Clayton Properties

Wildflower - Transitional 3Car

ROOF TRUSS PLACEMENT DIAGRAM

EVERSTEAD
SHOP DRAWINGS/SUBMITTAL REVIEW

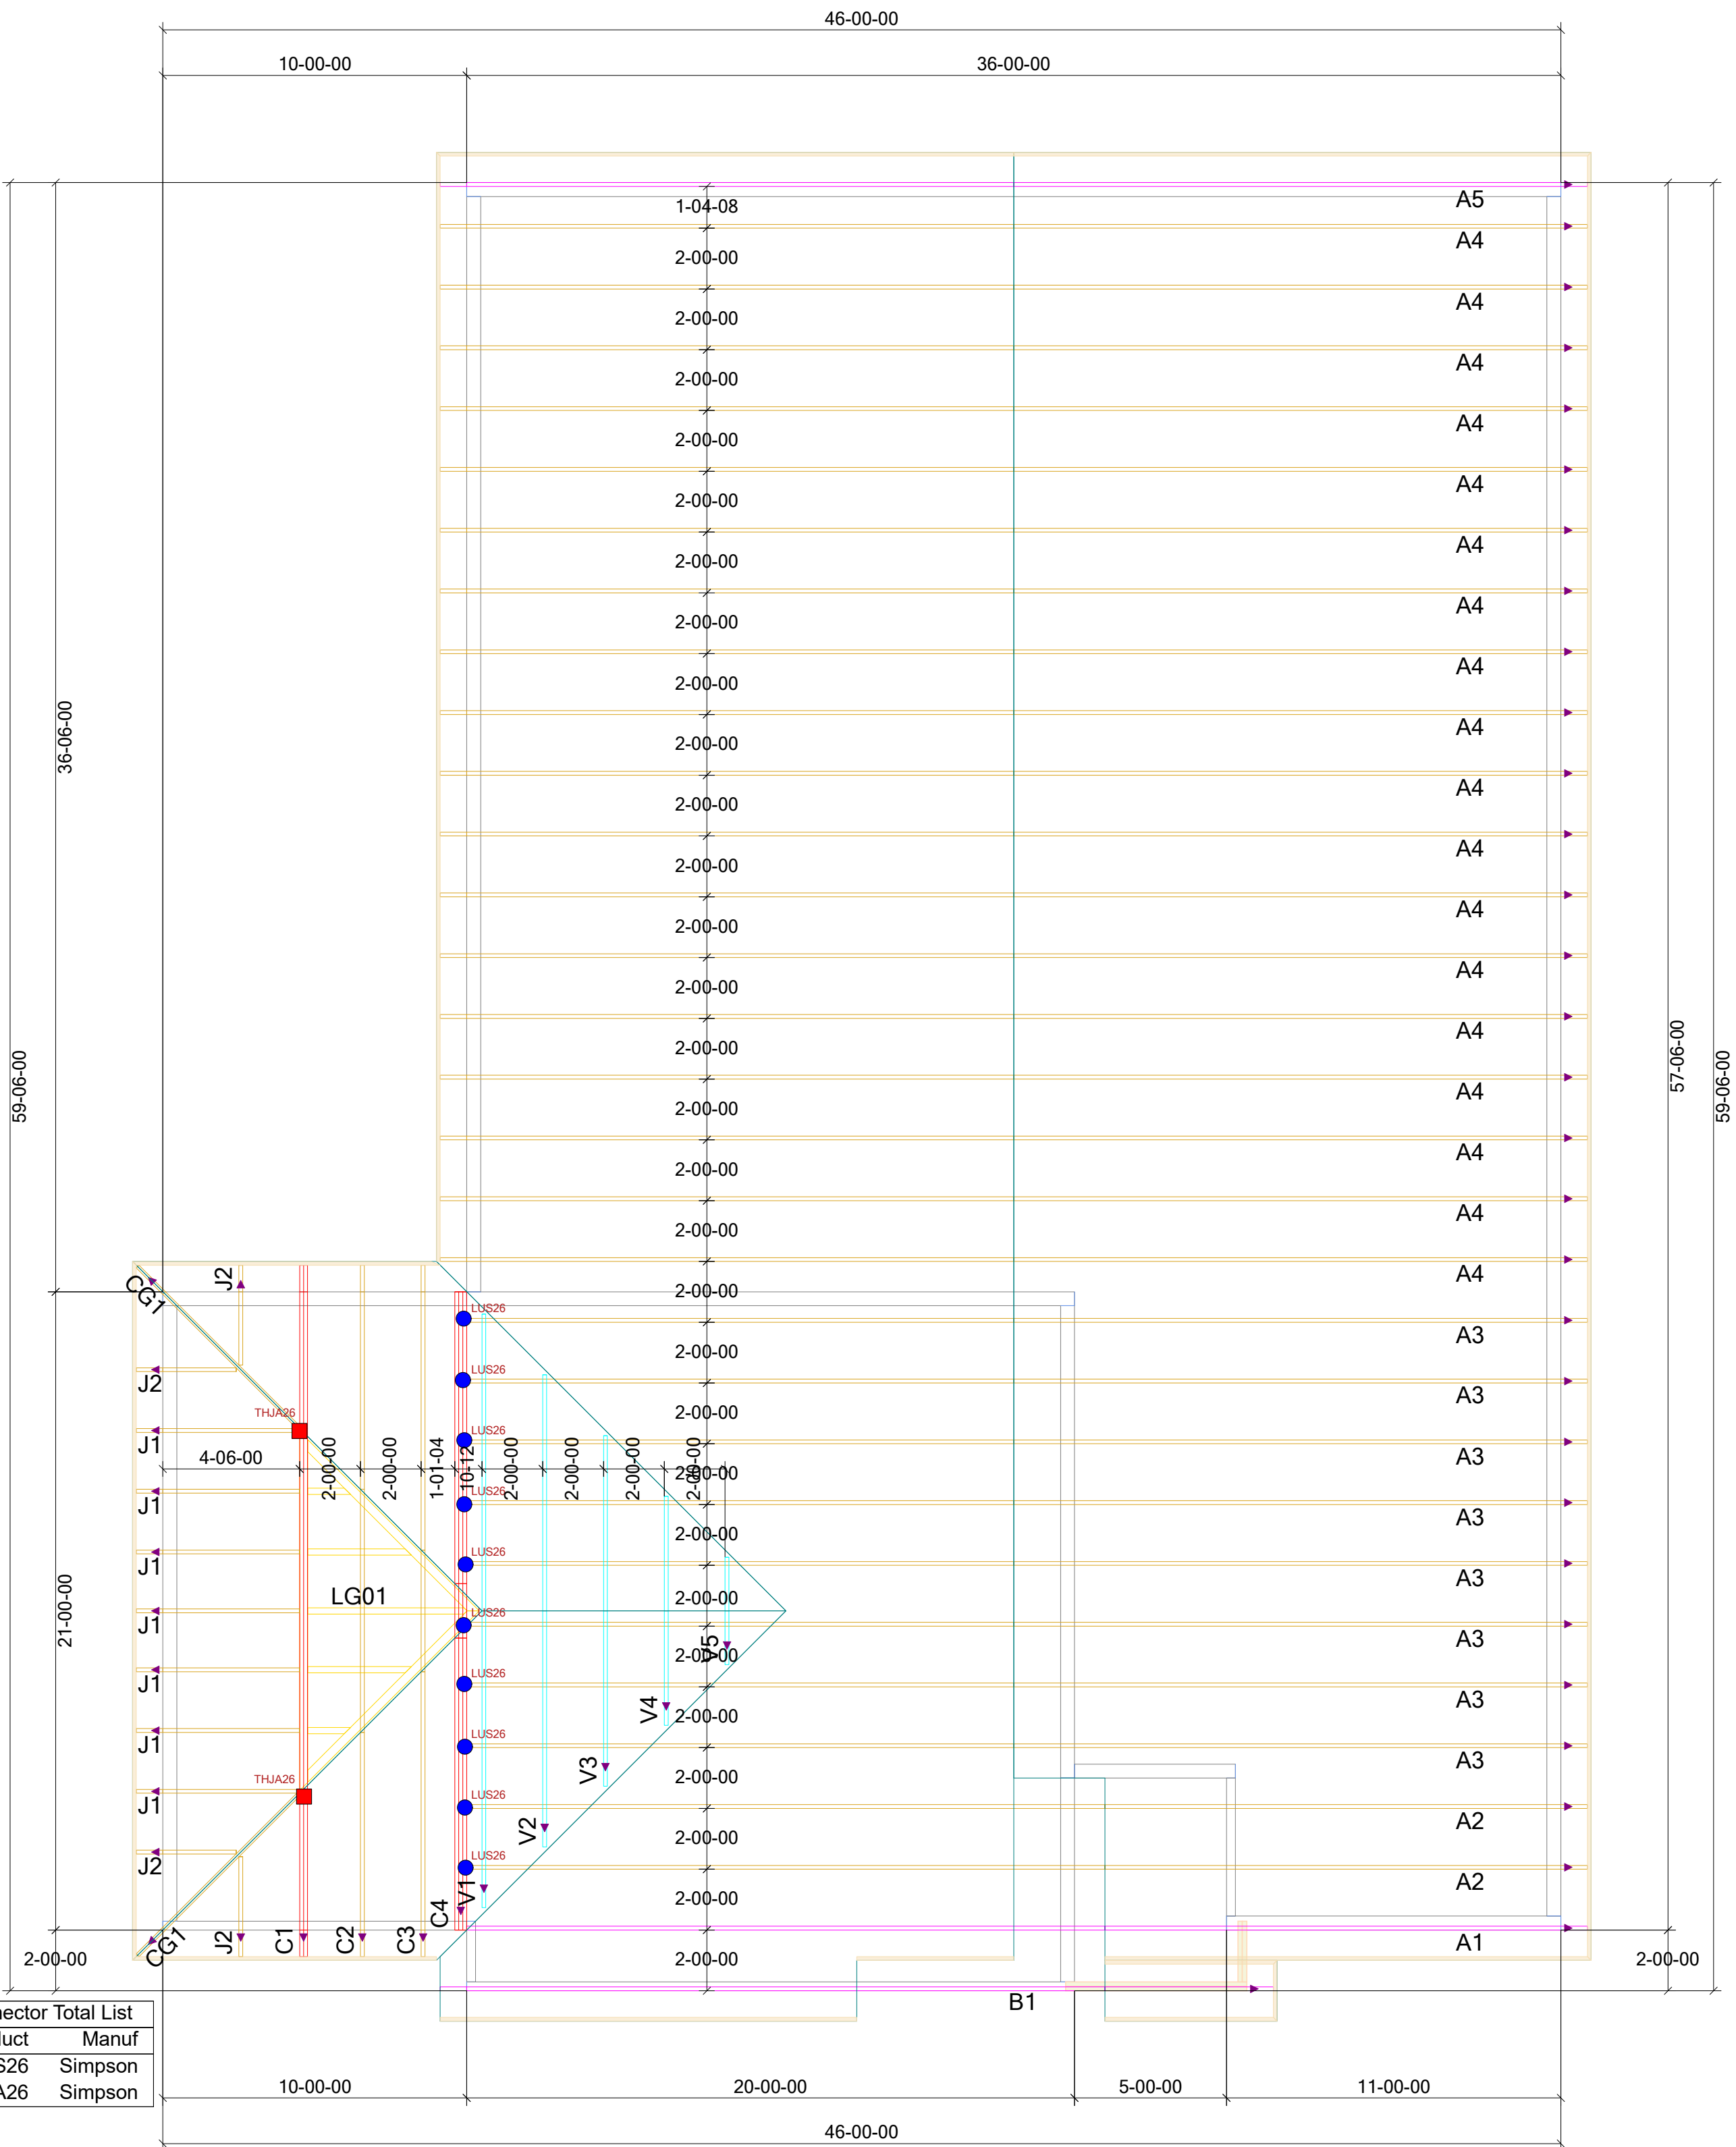
APPROVED
